EAGLE MOUNTAIN CITY

City Council Staff Report

FEBRUARY 18, 2014

Project:	**Evans Ranch Plat B-2 – Final Plat**
Applicant:	DAI (Agent – Nate Shipp)
Request:	Final Plat Approval
Type of Action:	Action Item; Public Hearing
Planning Commission:	Recommended Approval (5-0)

PLAT "B-2"

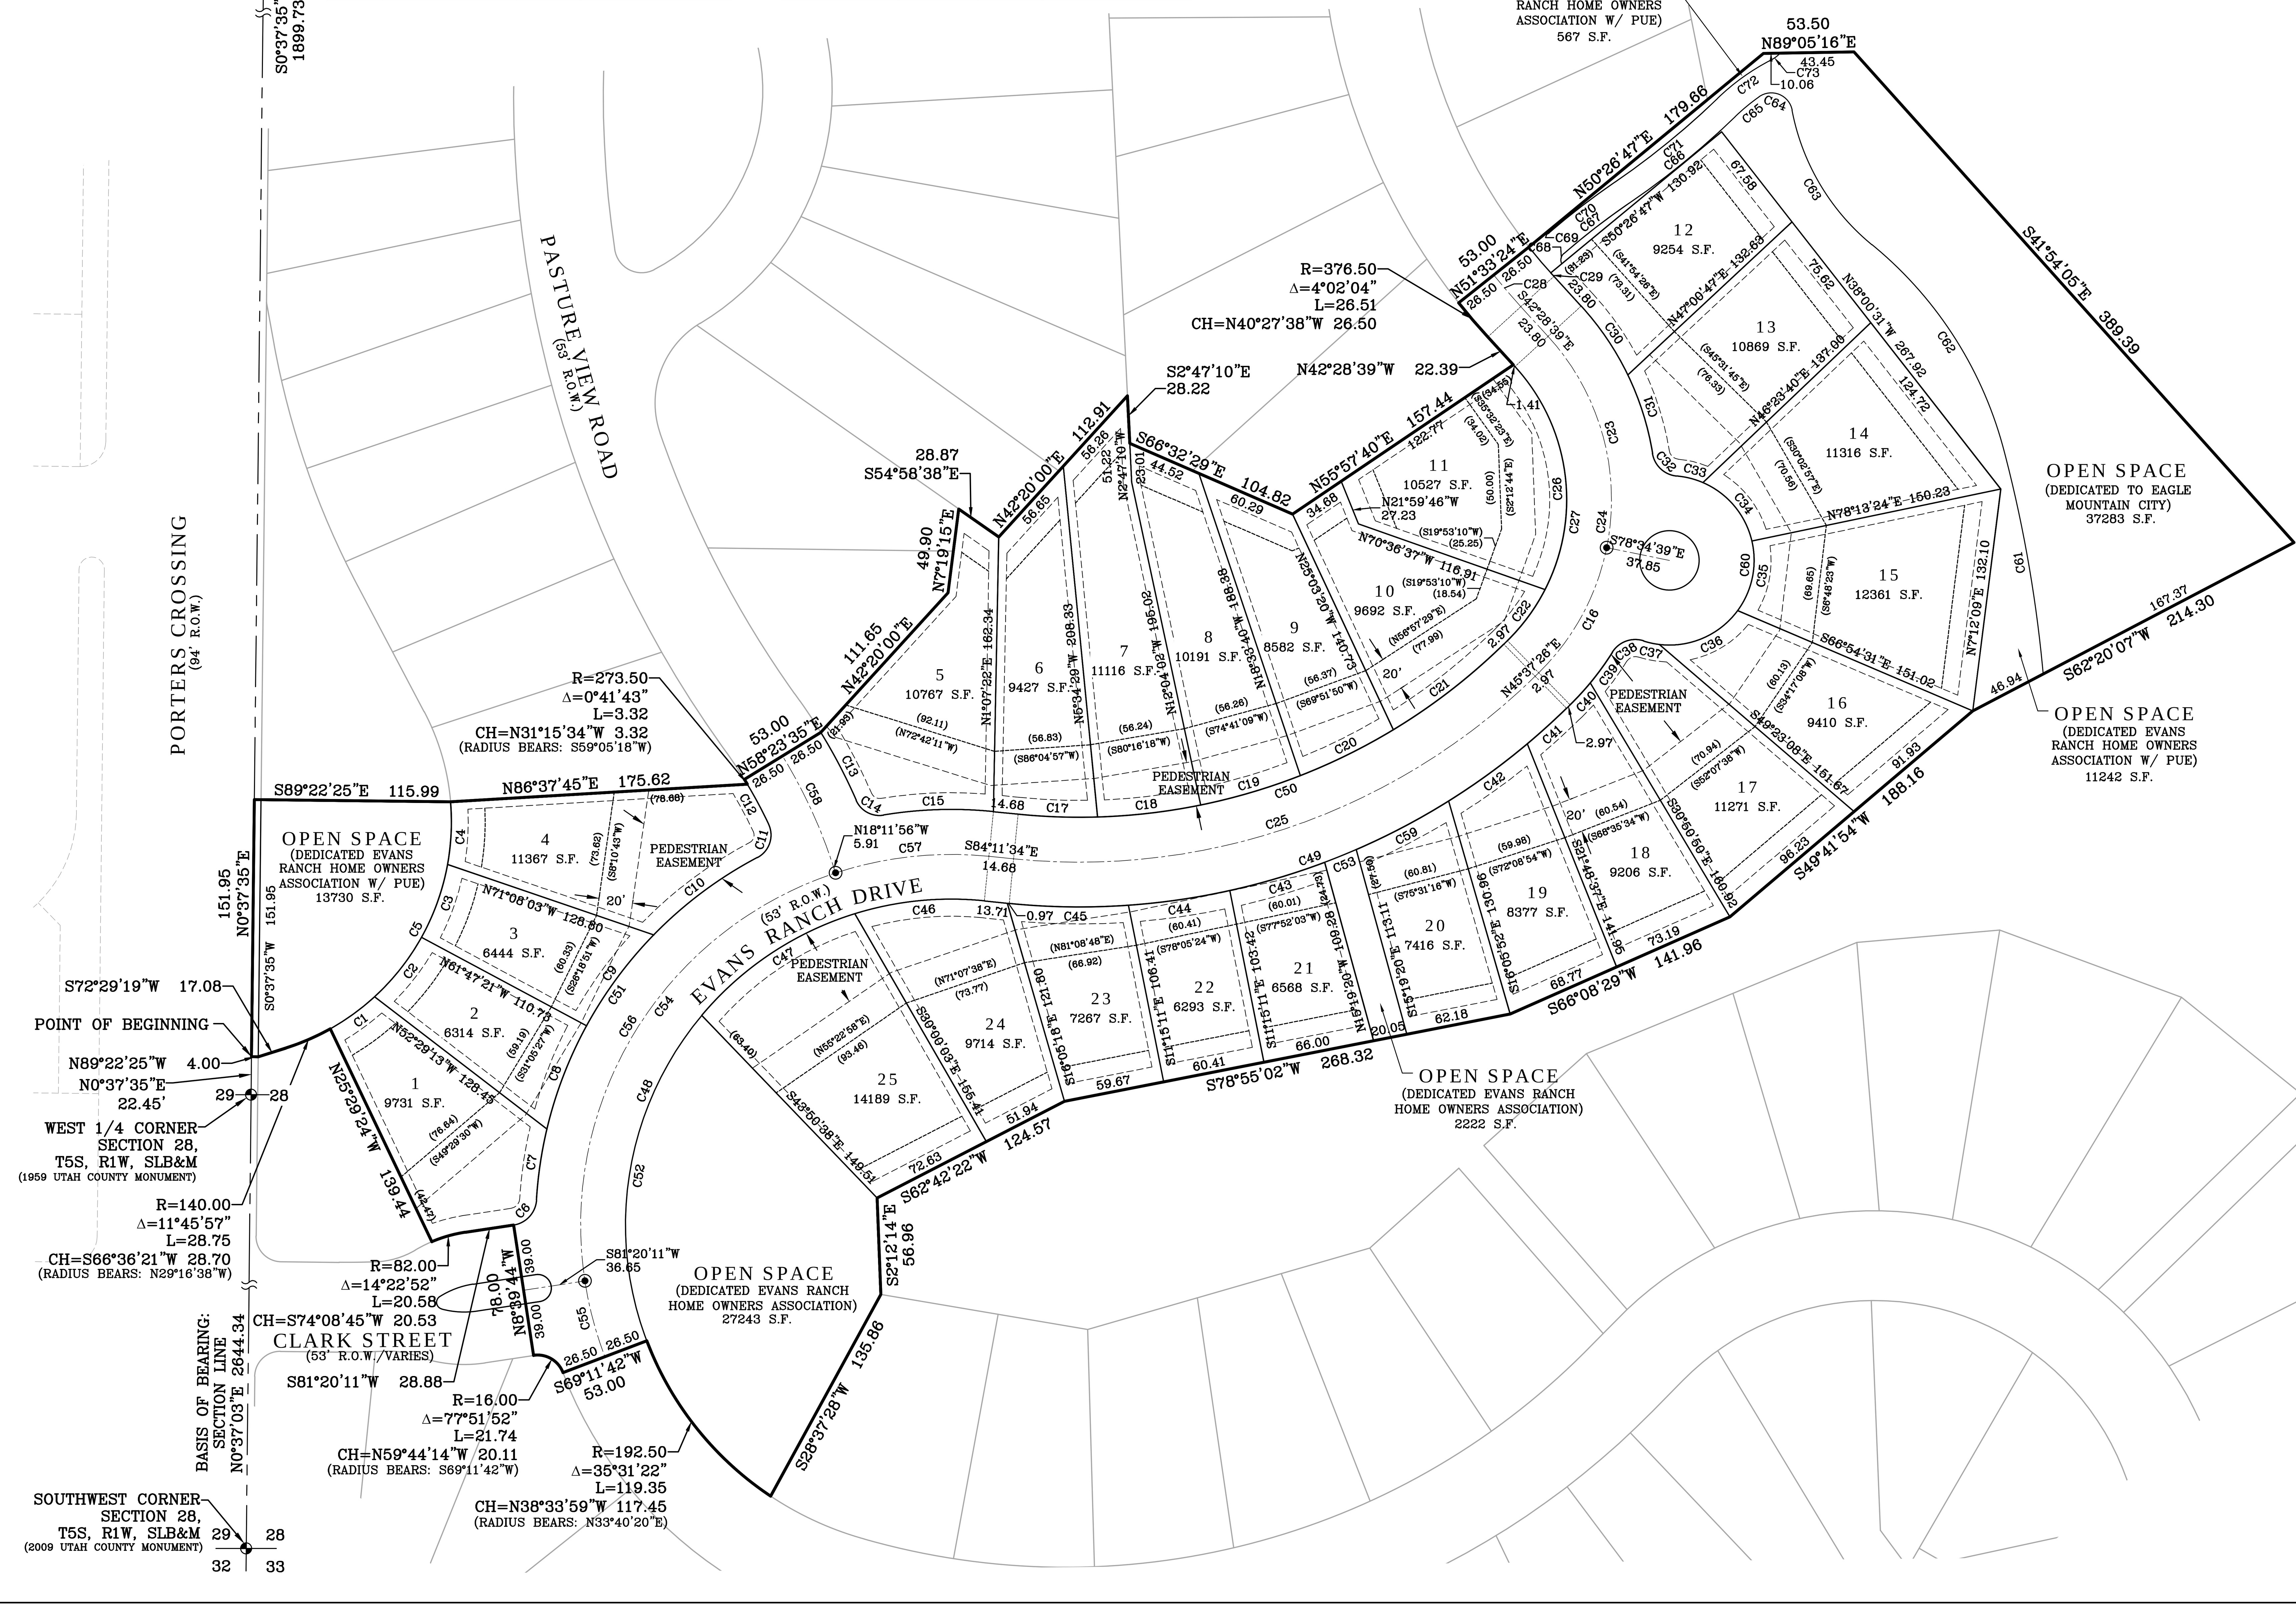
- Fencing – The plat indicates a 6-foot vinyl slat fence behind lots 1-4. This fencing must instead following the approved master fencing plan, which requires Cedar estate fencing for this area.

- Pedestrian Easements – Since these lots are planned with very specific build-to lines for the homes, as can be seen on the master plan above, there are pedestrian easements that extend onto each lot, allowing for the sidewalk to be located outside of the street right-of-way.

- Open Space Dedication - As approved with the master development plan, the open space including the trail, detention basin, and native area to the east of the trail (behind lots 12-15) will be dedicated to the City. The remainder will be dedicated to the Evans Ranch Home Owners Association. A public utility easement will be provided to the City on the open space along Porter's Crossing, mostly in order to locate some electrical boxes/equipment within this area.

OFF-SITE SEWER PLAN & PROFILE

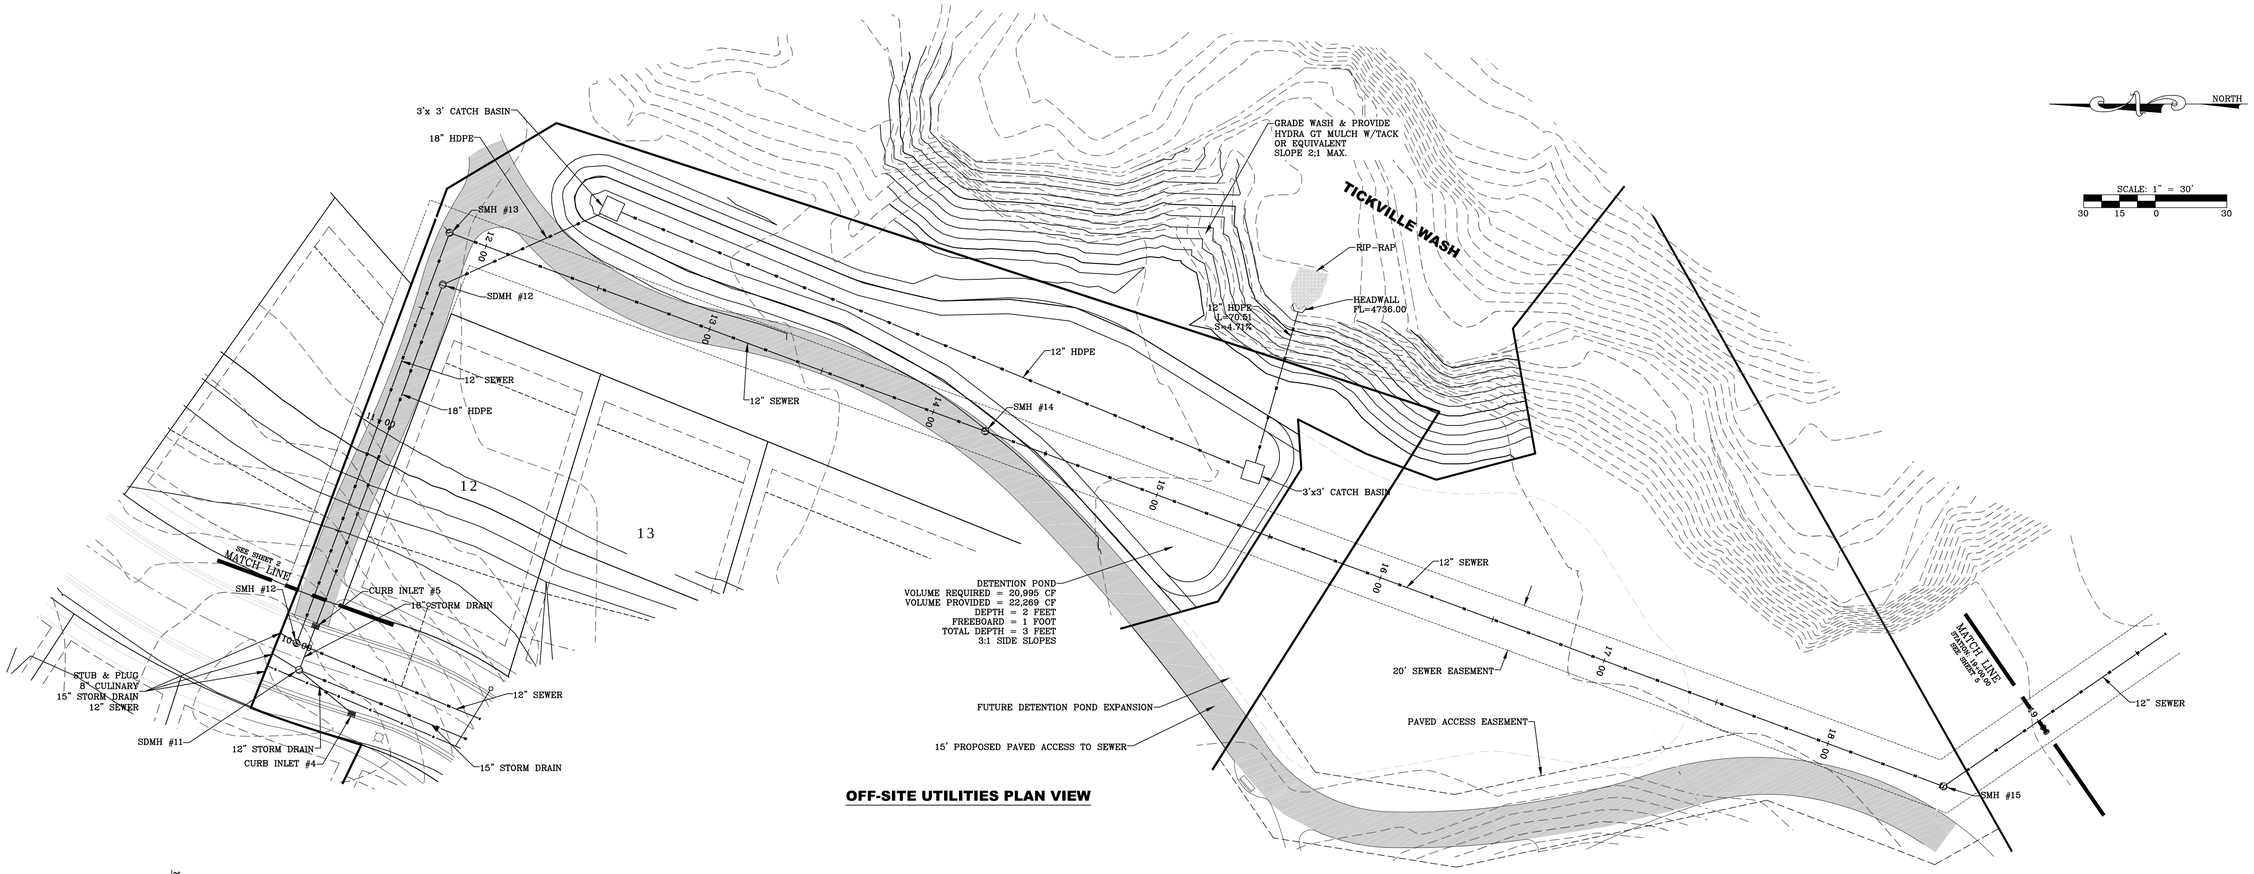
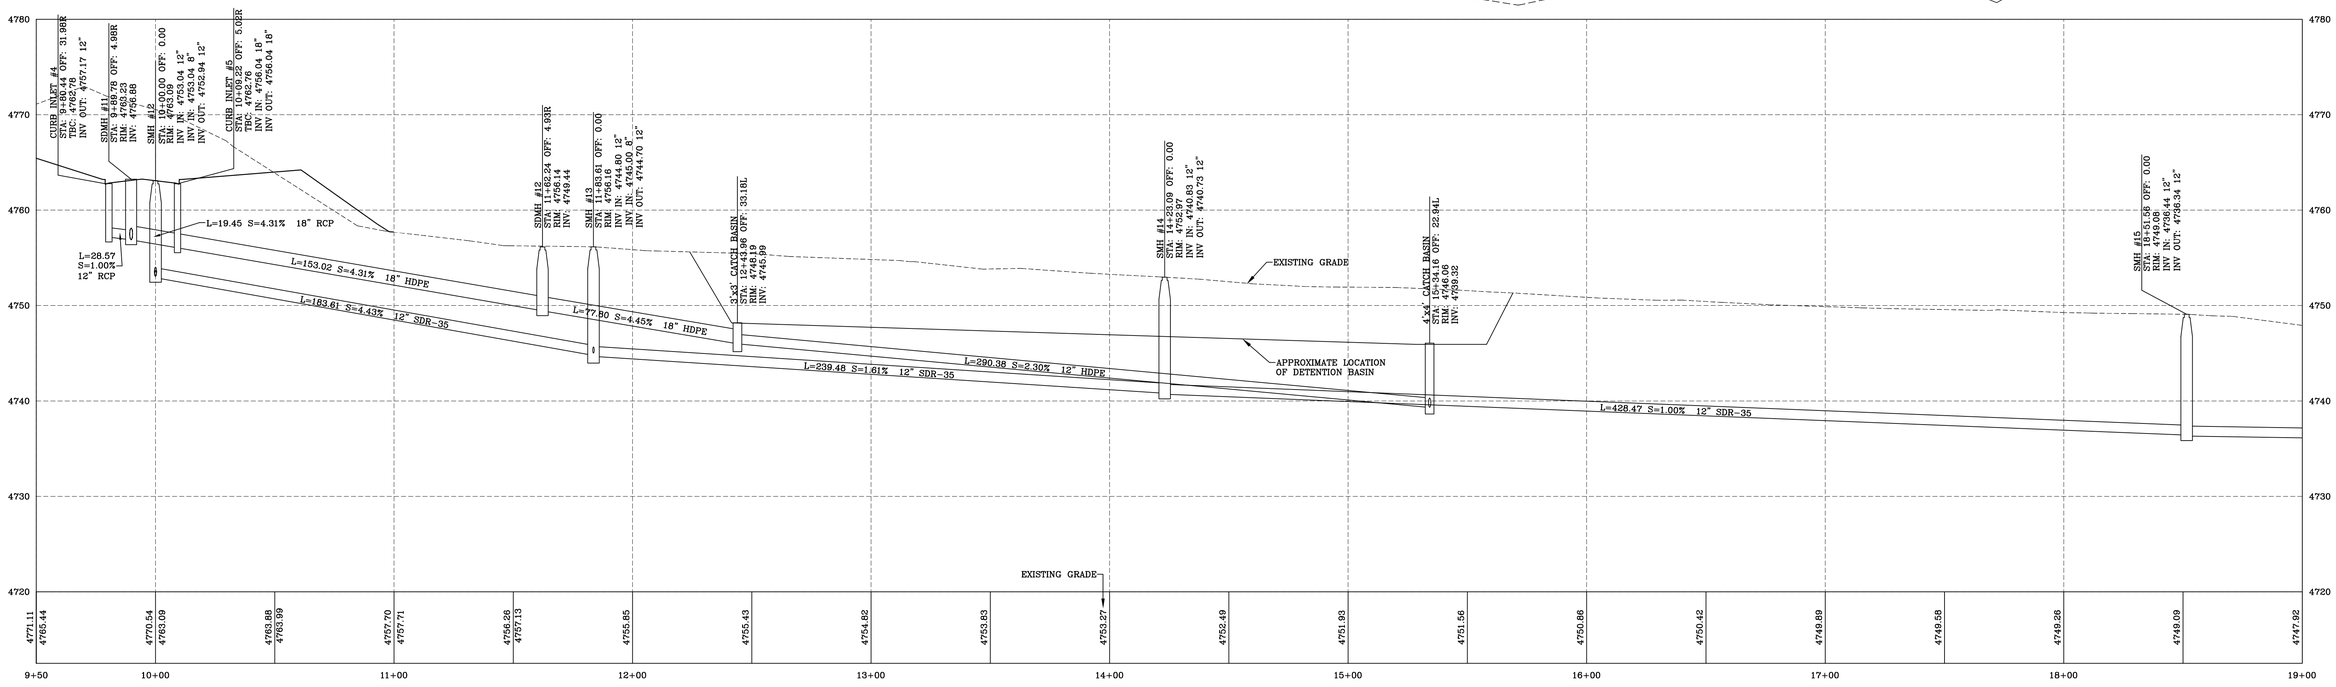
- Utilities - This development requires that a sewer line be built that extends to the east, crosses the Tickville Wash, and connects to the SilverLake sewer pipe in Silver Creek Way. This gravity sewer line will ultimately allow the neighborhoods to the west to gravity feed into this line, and the sewer lift station can possibly be removed. In order for this sewer line to be built the developer must obtain an easement for the City from Silver Lake Land LLC, and must work closely with the City Engineer on the design and construction drawings.
